**DEVELOPMENT REVIEW BOARD**  
**TRANSPORTATION DEVELOPMENT**  
**Standard Comment Sheet**

DRB-1004561                      Item No. 18                      Zone Atlas    H-17

**DRB CASE NO/PROJECT NO: 1004561**

Re: **Sketch Plat Review and Comments Lots 1 through 5, 6A, Block 13, Timoteo Chavez Addition, Zone Atlas Page H-17-Z, Containing ± 0.9053 Acre**

Existing Site Plan

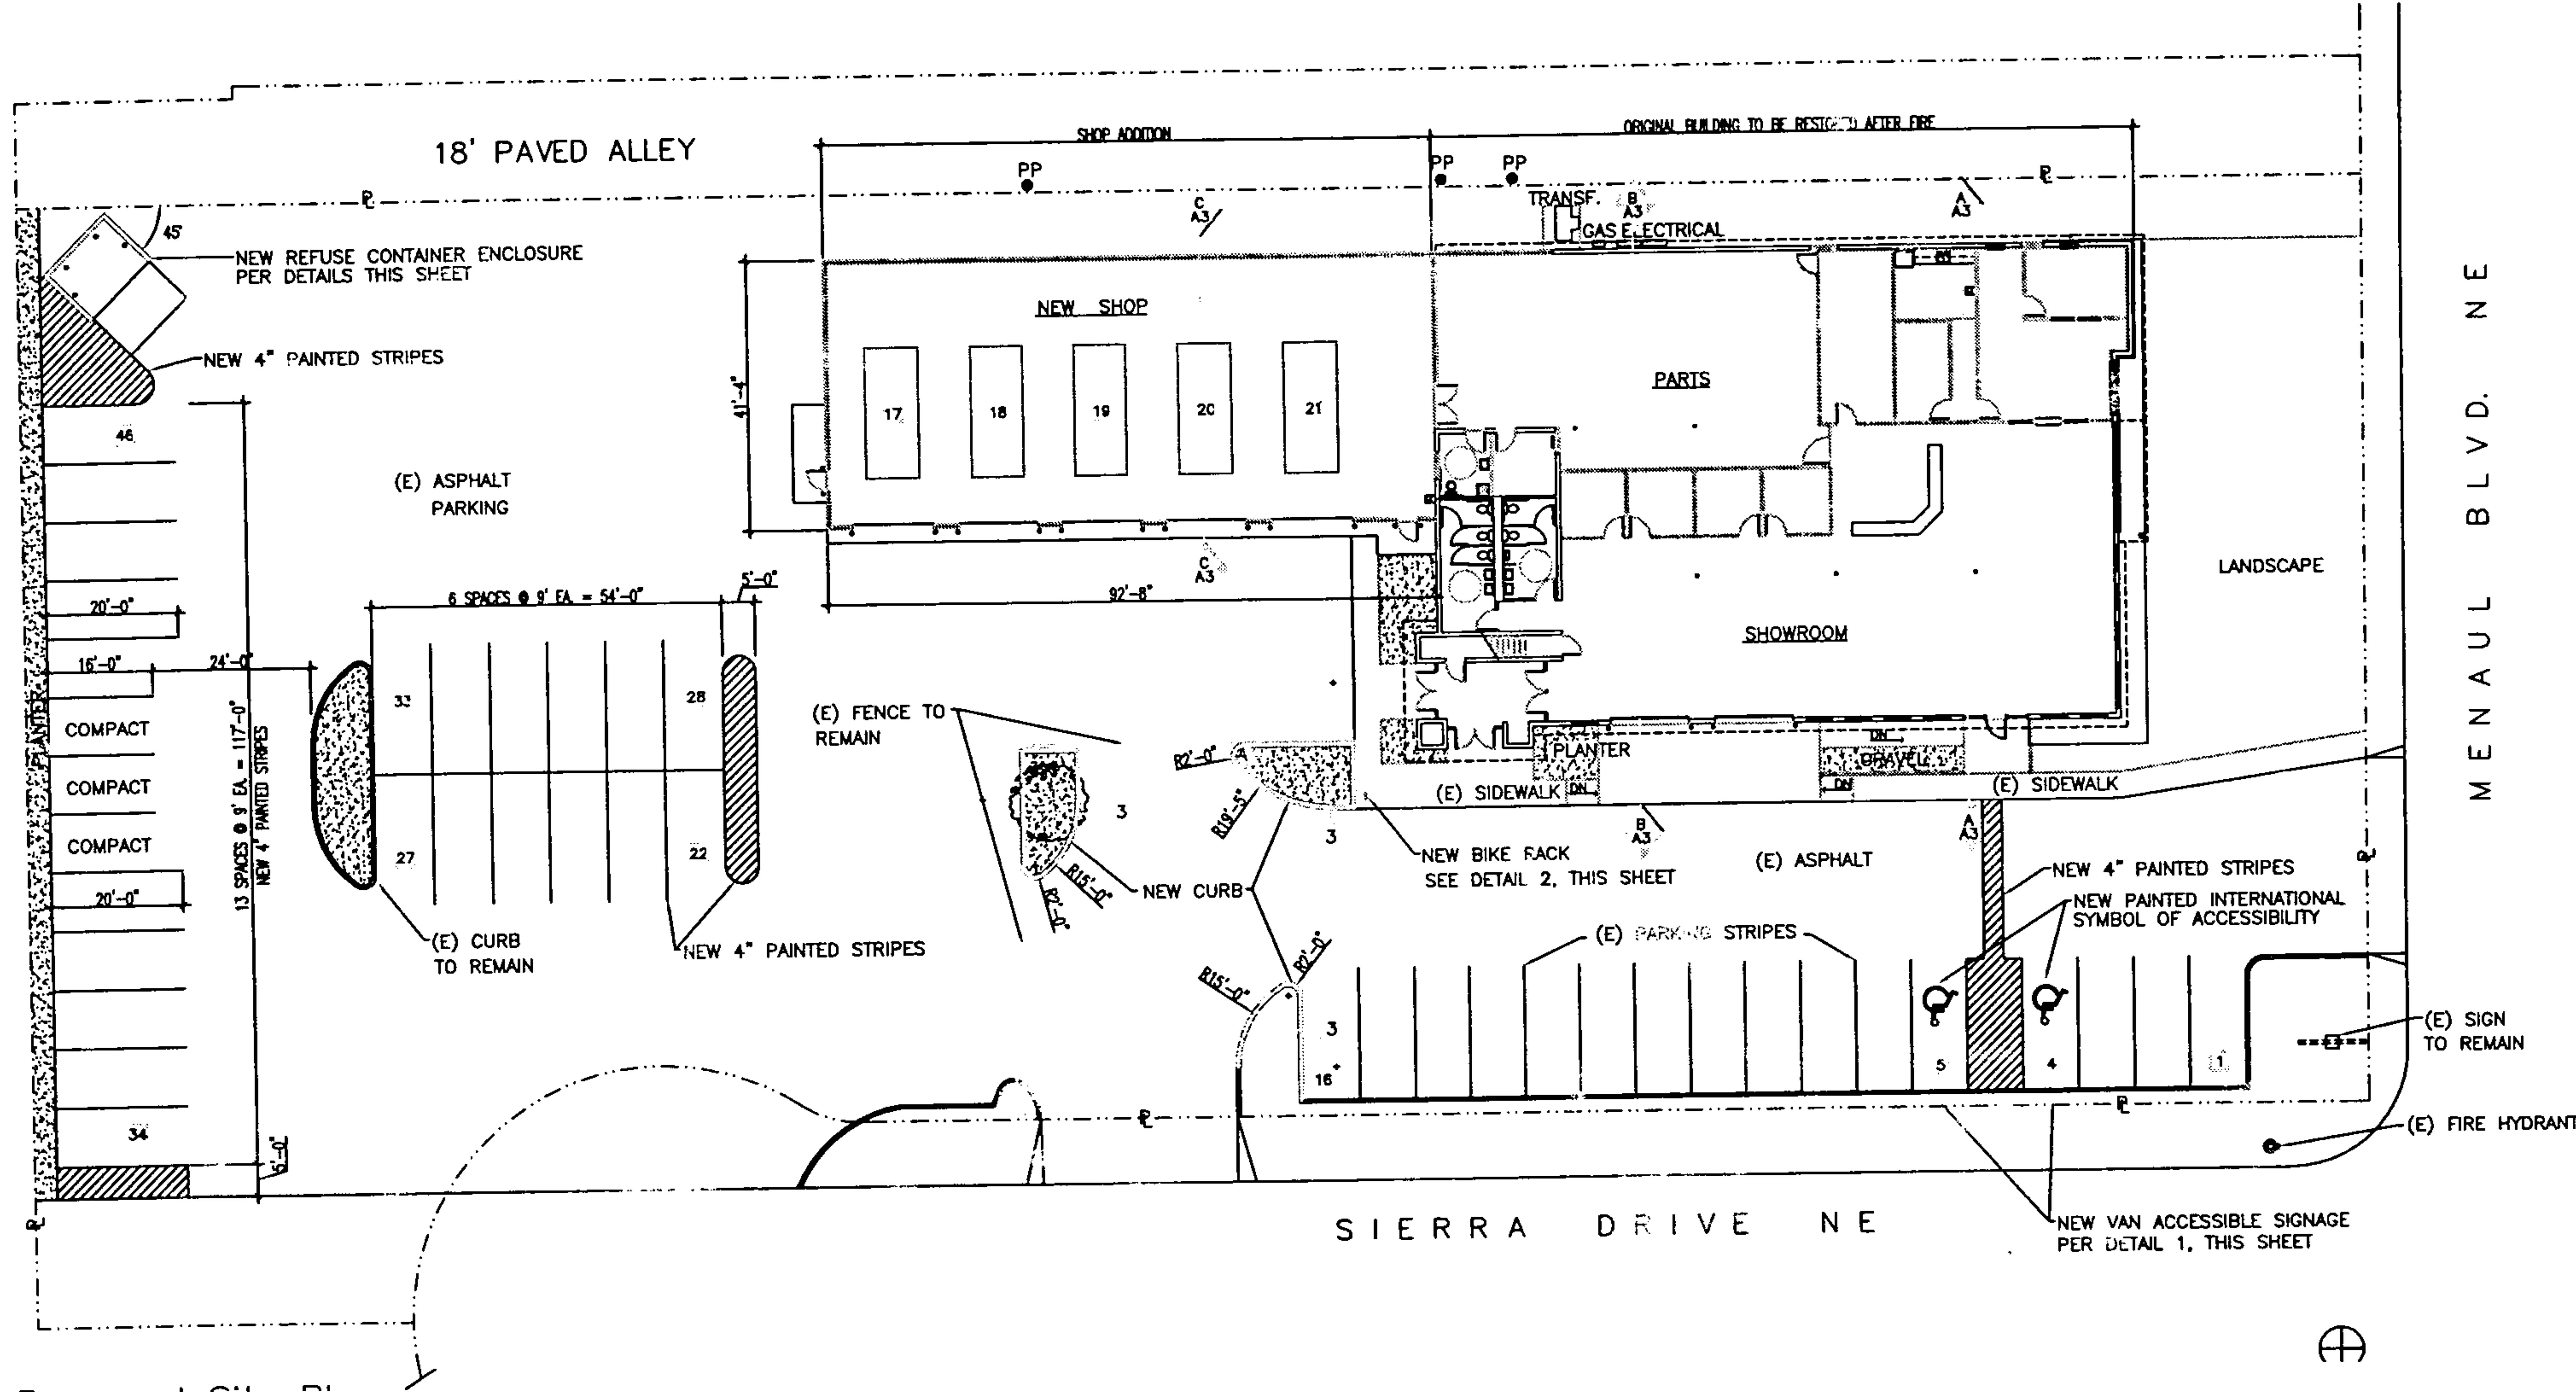
- 1) Radius dedication will be required on Menaul and Sierra.
- 2) What is the distance from face of curb to the property lines? (Should be a min. of 10')
- 3) What are the widths and conditions of the sidewalks?
